## Firmware 2.06.3 bug list:

## List of bugs/improvement requests

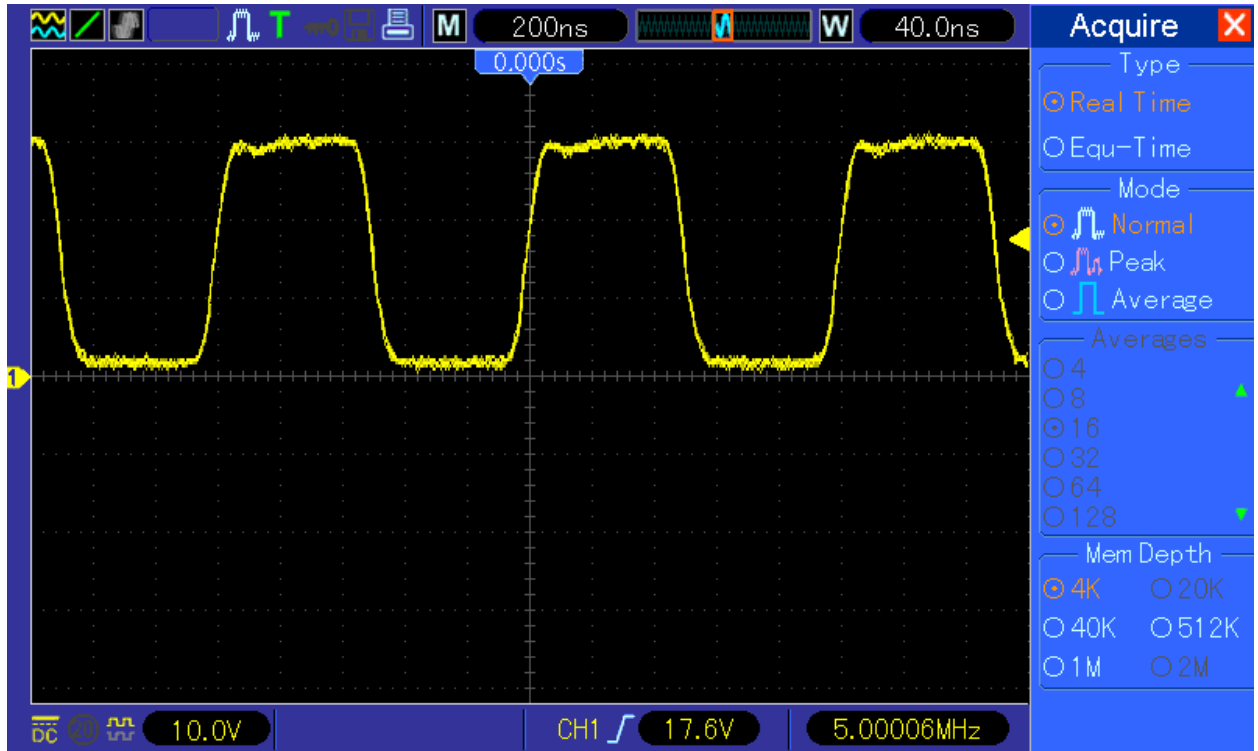
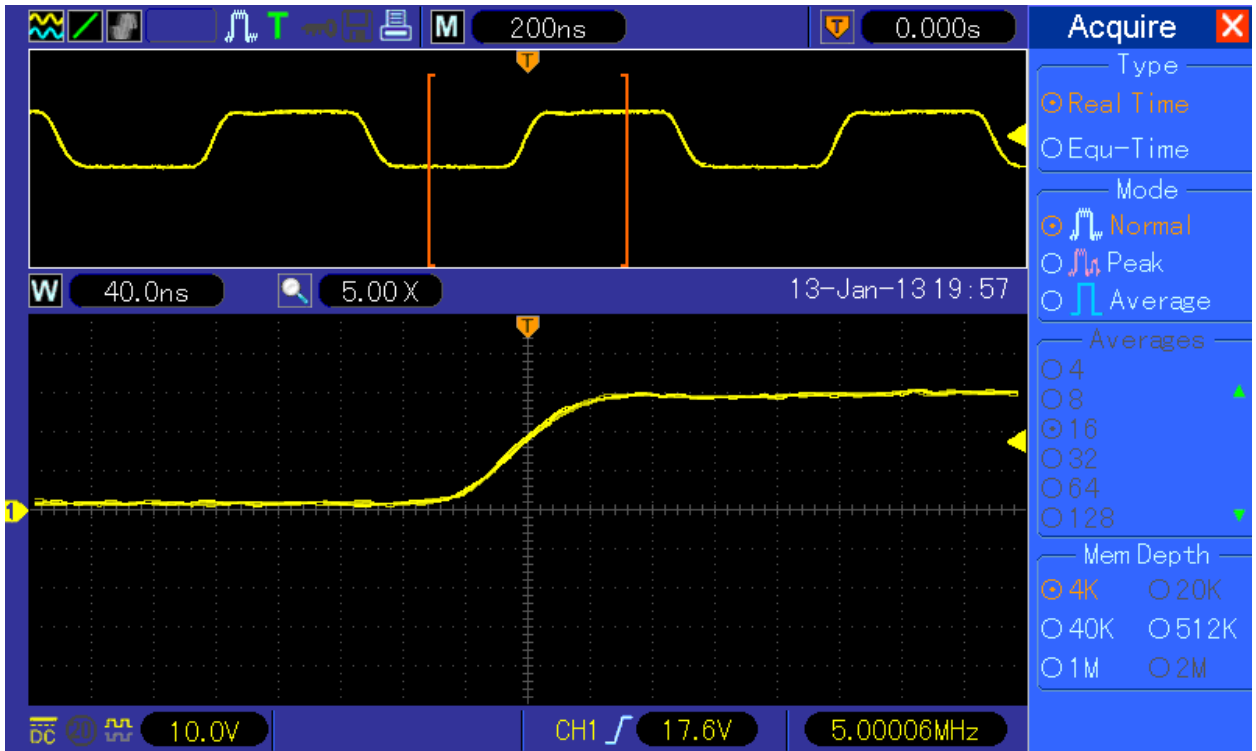
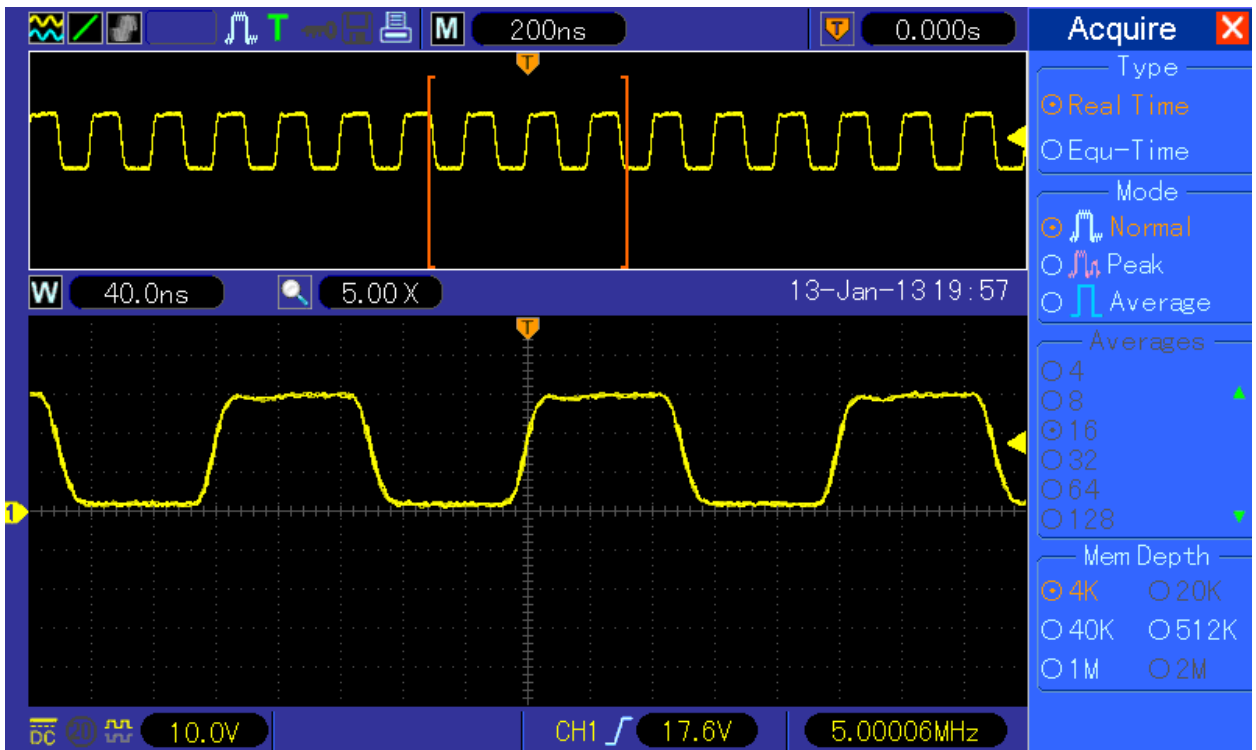
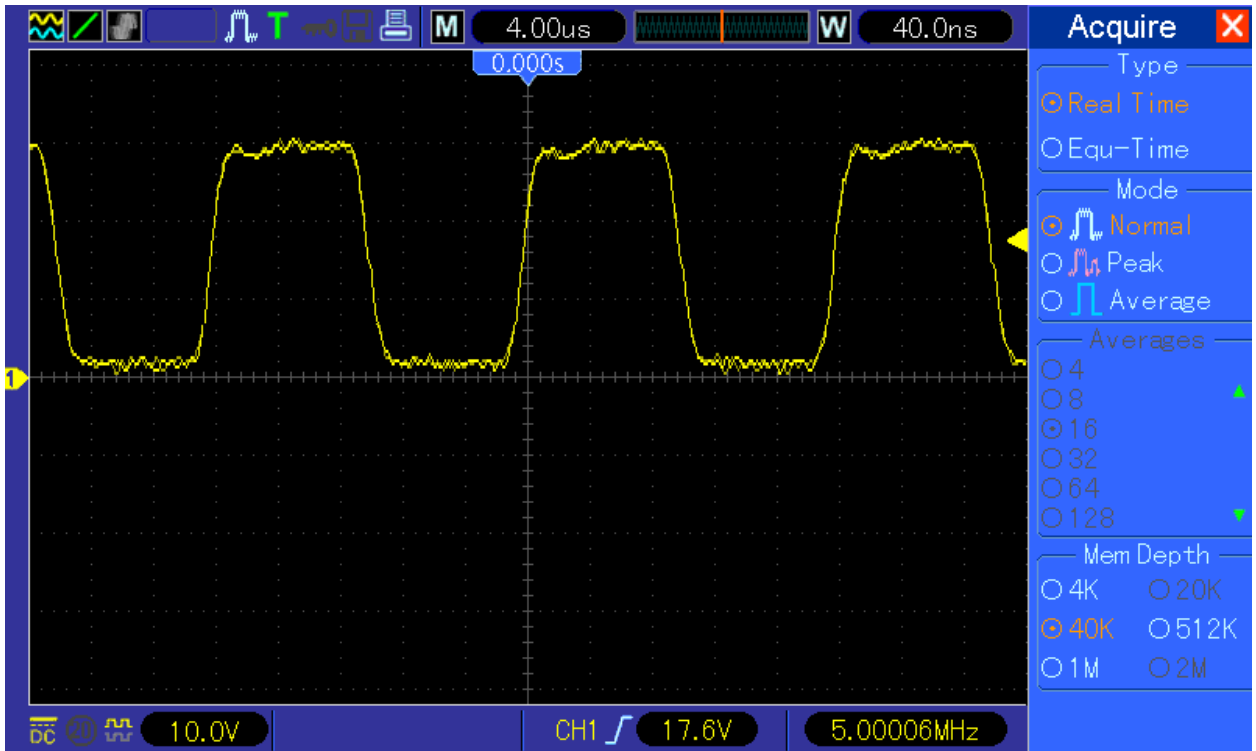
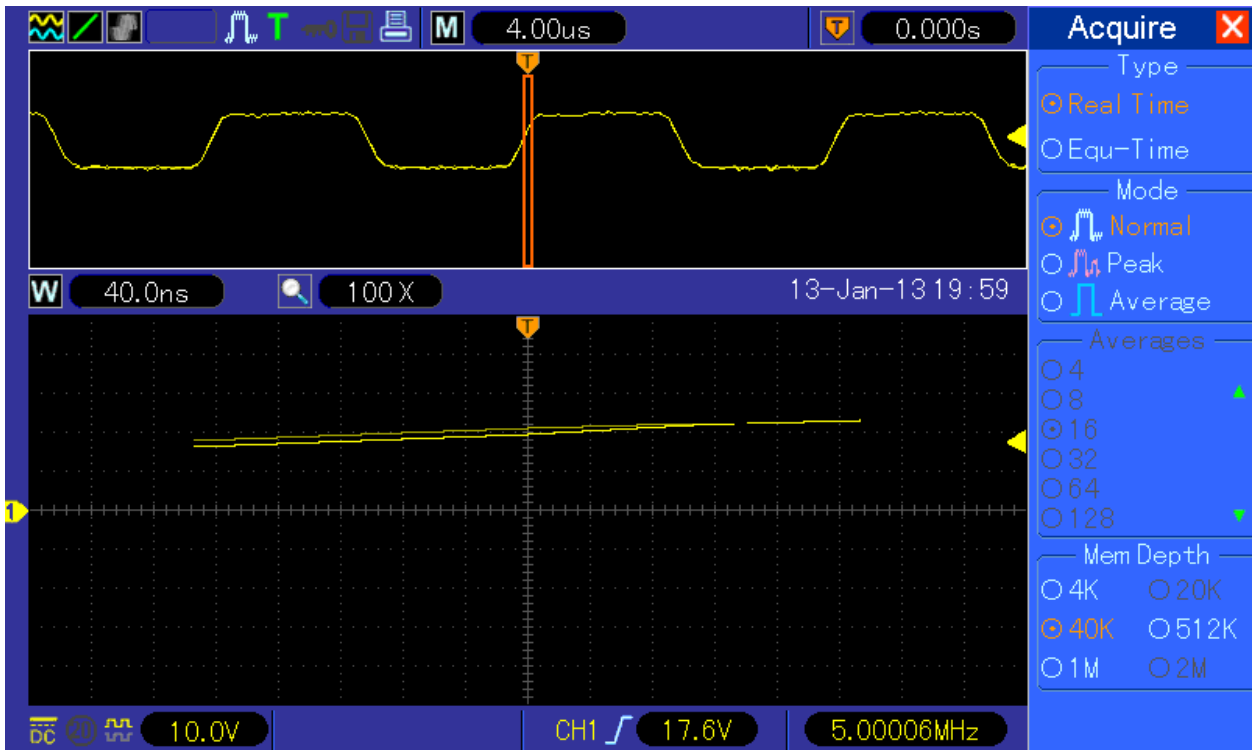
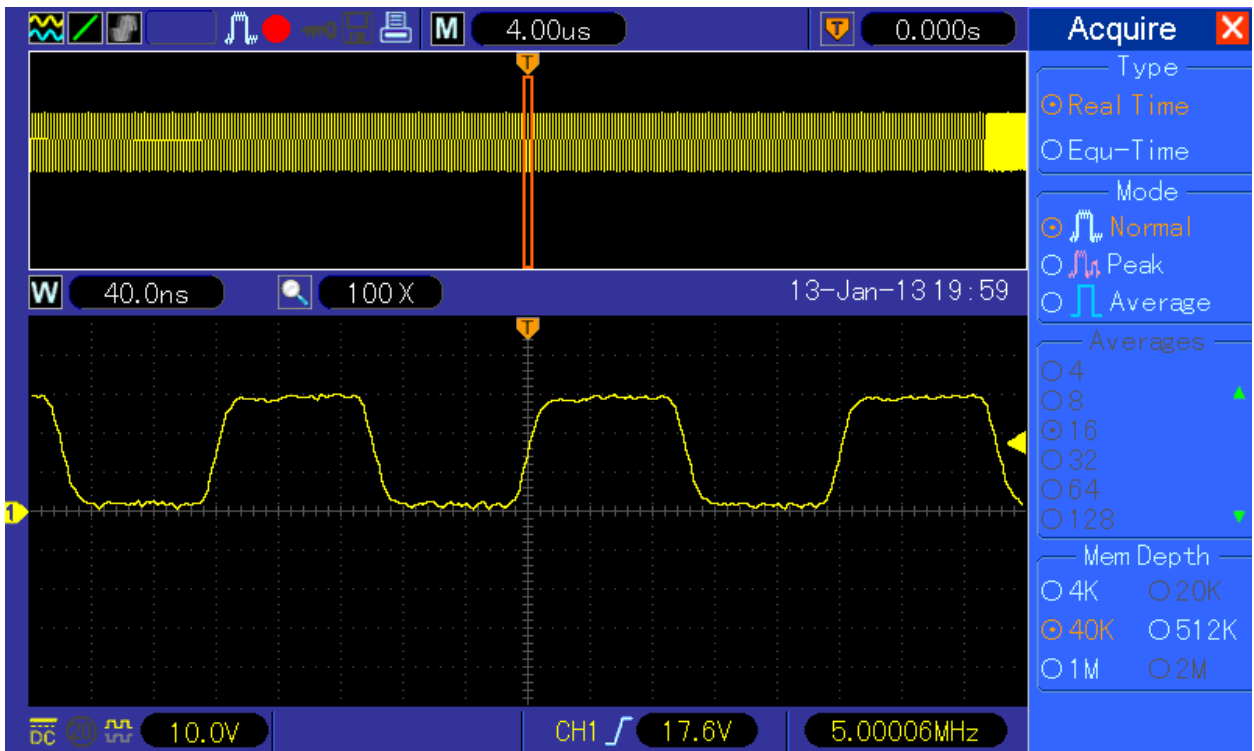
26. While switching to Dual Window (F7) , if  $WTB < MTB$ , the MTB displayed value is not always set properly. **Up to fw 120423.0 it was working properly, in 120808.0 and 121027.0 the MTB scale changed in a completely wrong way (see bug 27), in fw 121208.3 following behavior:**

Example1: 4k depth, 5MHz signal, 40ns/DIV WTB

now when we change with F7 to dual window the top window is showing wrong scaled waveform, the resulting bottom zoom window showing as well wrong :

when we turn now the Timebase knob one position “up” (200ns/DIV is actually to max “up” position for MTB by 4k depth, but by turning the knob firmware is updating windows) the waveform in top and bottom window is properly scaled:

Example2 : 40k depth, 5MHz signal, 40ns/DIV WTB

now when we change with F7 to dual window the top window is showing wrong scaled waveform, the resulting bottom zoom window showing as well wrong :

when we turn now the Timebase knob one position "up" (4us/DIV is actually to max "up" position for MTB by 40k depth, but by turning the knob firmware is updating windows) the

waveform in top and bottom window is properly scaled:

26. ~~Just ignore it for now; it is interim fw version — for testing only.~~ This is no in production firmware as well, very annoying bug.
27. Switch once focus from minor (bottom window) to major (top window) window by pushing timebase knob down, turn then timebase one position fort and back to get rid of waveform artifacts on left and right side of the waveform.

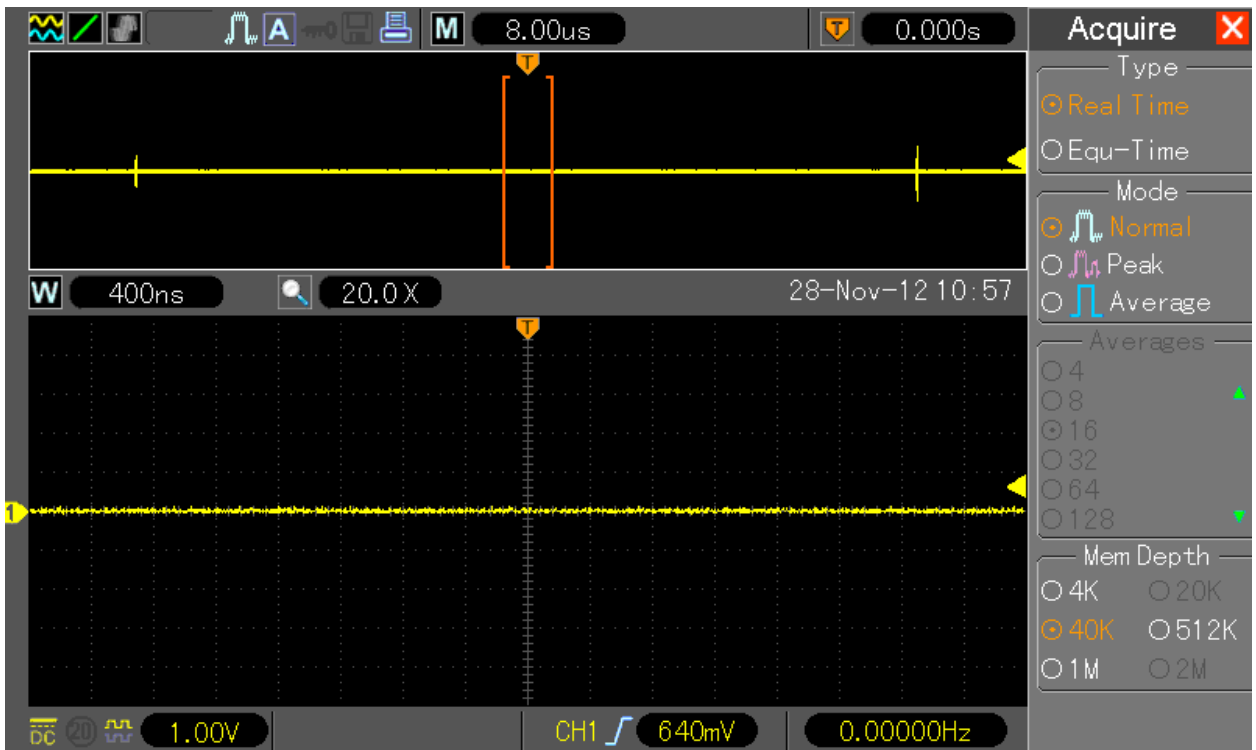
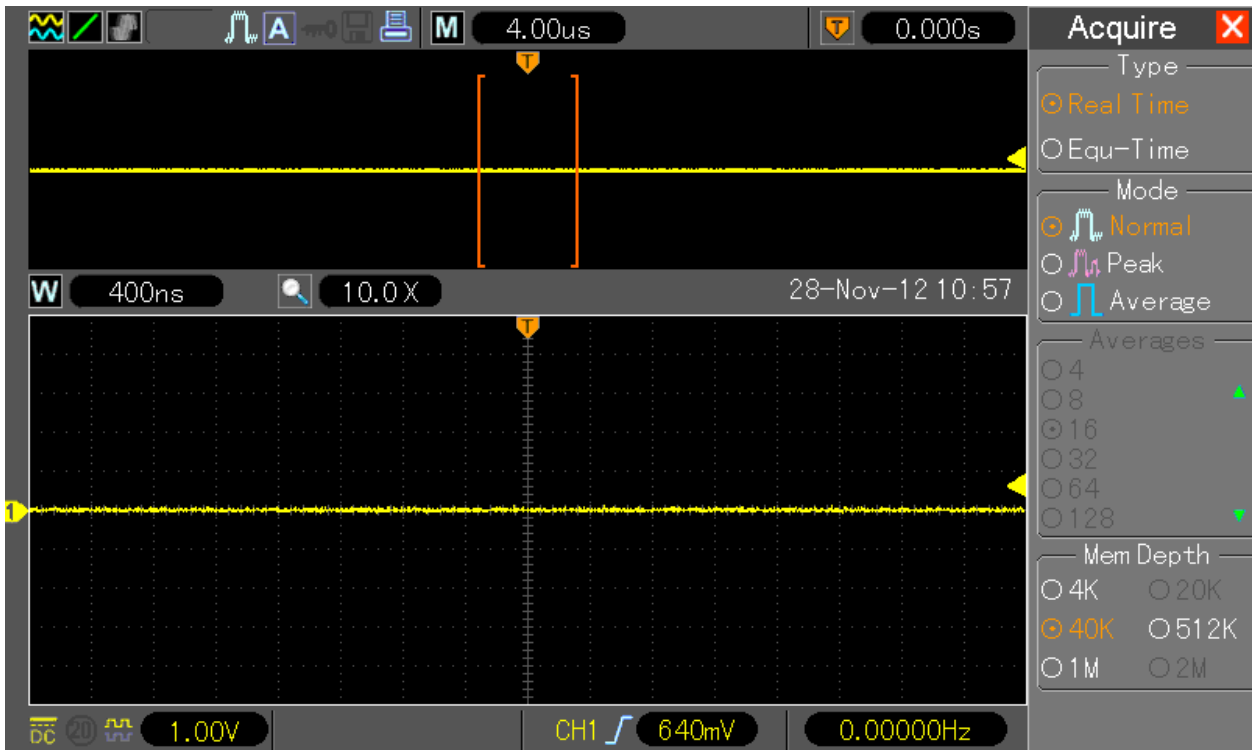
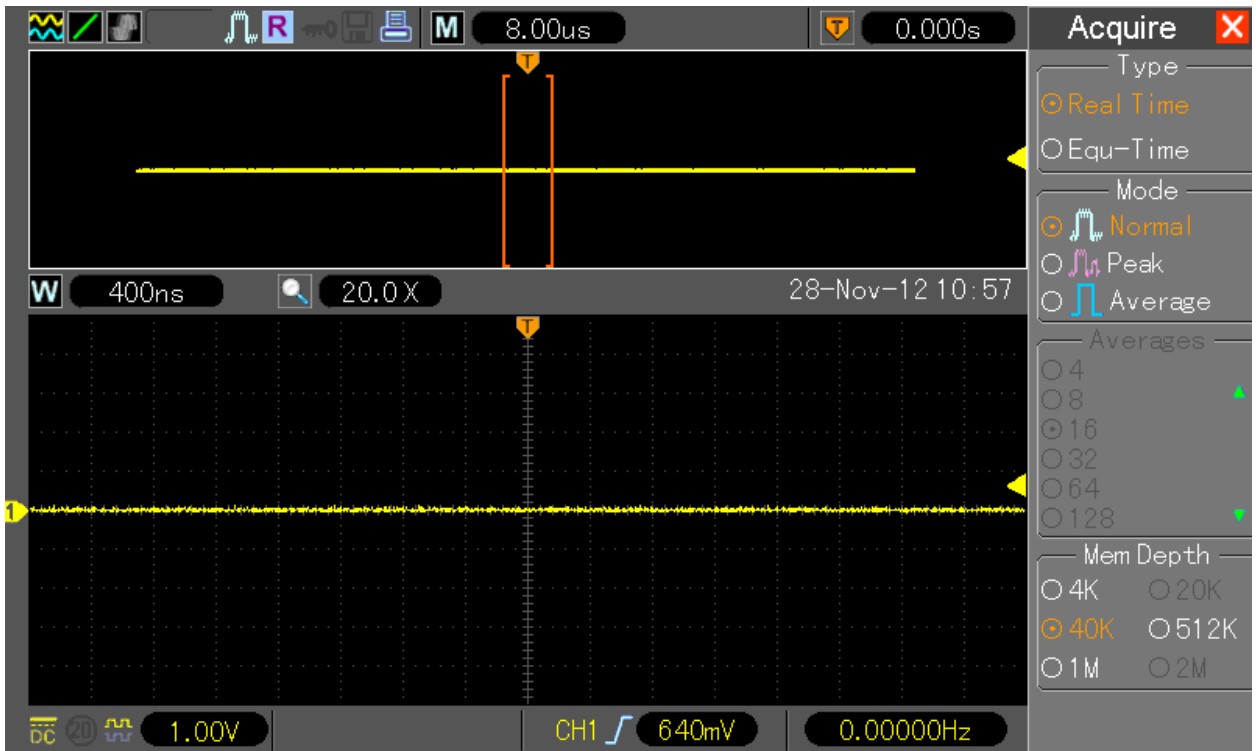
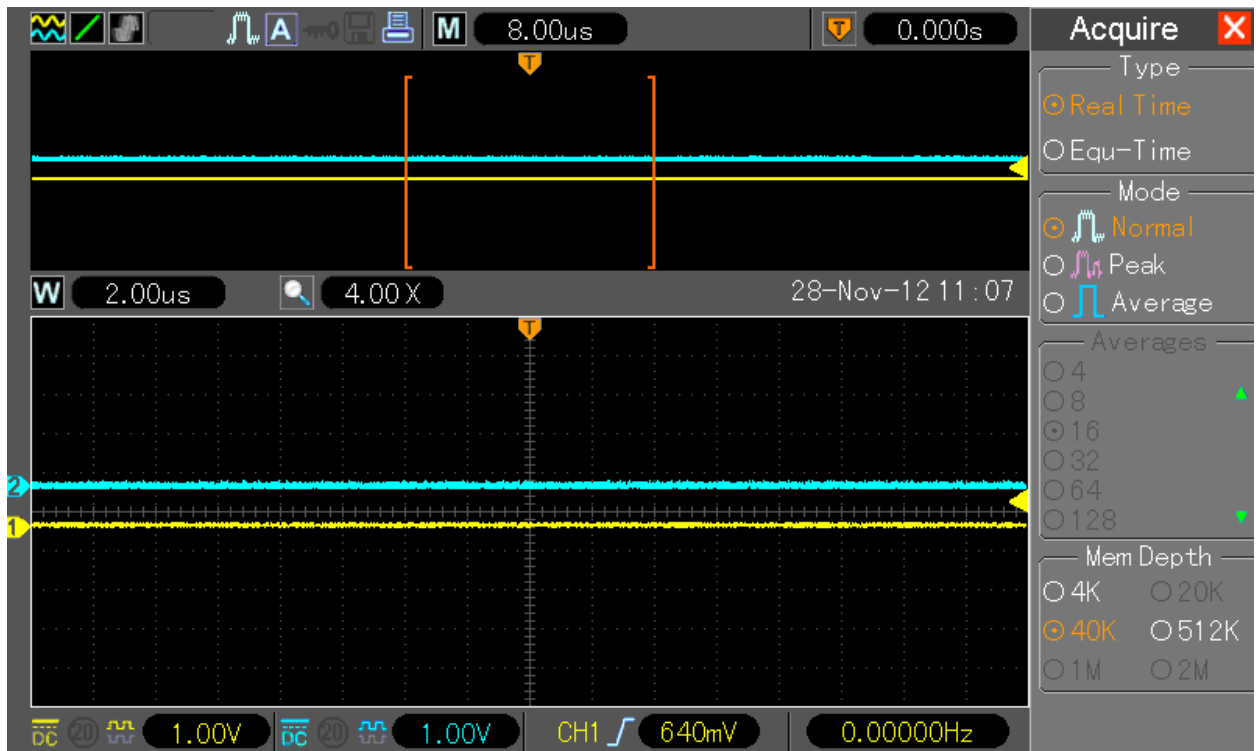
27. While switching from single into dual window mode the main timebase is changing with a wrong factor, e.g. from 200ns/DIV in single into 400ns/DIV in dual window mode. Similar issue in 40k/512k and 1M – in dual window the MTB is twice that high as before in single window mode. Due incorrect timebase the display buffer is showing artifacts on both right and left side of the waveform (end of buffer). Example: CH1 enabled, 40k memory, single window and windows timebase smaller than main timebase, here 400ns/DIV (Main TB is 4us/DIV for 40k)

Now when switching to dual window the Main TB is changing to wrong value (here from 4us/DIV to 8us/DIV – actually it will be always doubled in length) and artifacts from “end of buffer” right and left in top window are shown:

When the Acquisition would be stopped and restarted or Timebase changed one position forth

and back (while Main window is focused) the Main TB and displayed data will be fixed to proper length; no artifacts shown anymore:

With 2 channels enabled this bug **DOES NOT EXIST**, this is because the doubled Main TB value is exactly what it should be for dual channel view:

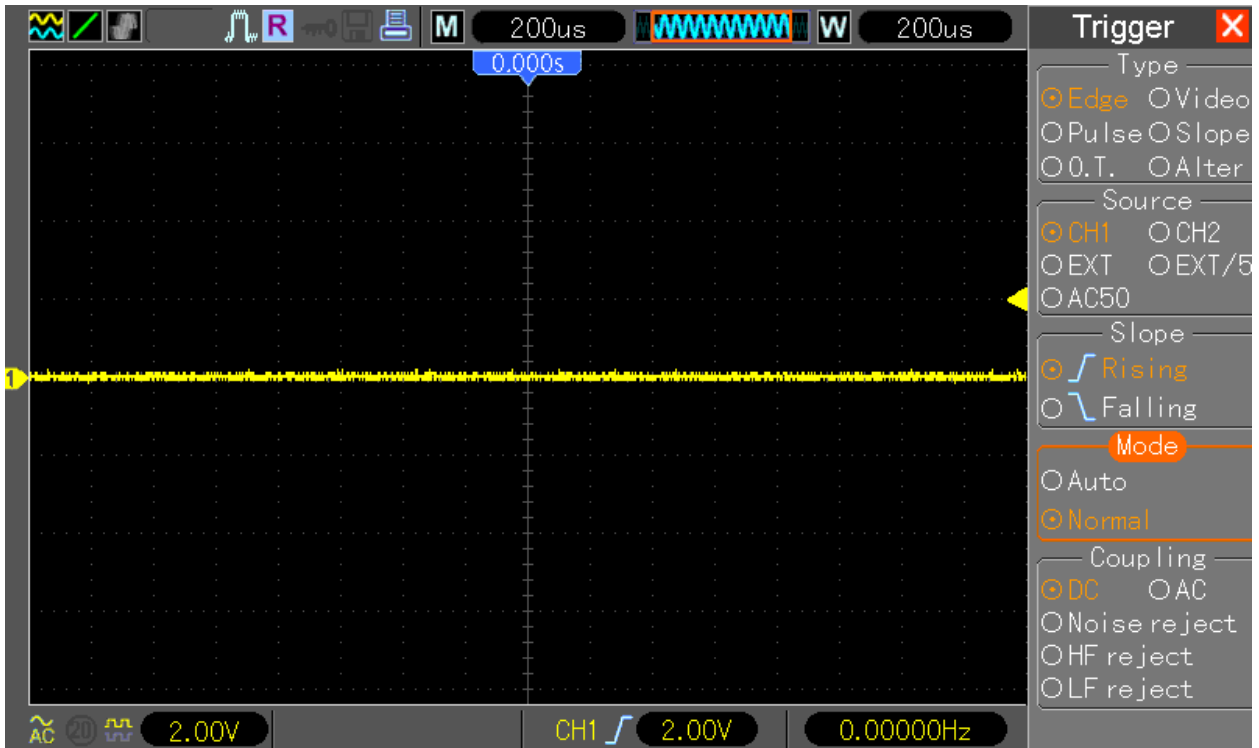
29. Horizontal Position knob not moving display data. Set Trigger to “Normal” – when DSO not triggered the waveform/horizontal screen position cannot be changed. Once triggered it changing rapidly. Another example – set trigger to Single Seq and Auto , while trigger in “R” (ready) mode waveform/horizontal screen position cannot be moved. Again, once triggered it change rapidly. **In firmware 110923.1 this was working! :**

but since few firmware version not anymore working (same condition, Horizontal position knob already turned few times but no move on screen):
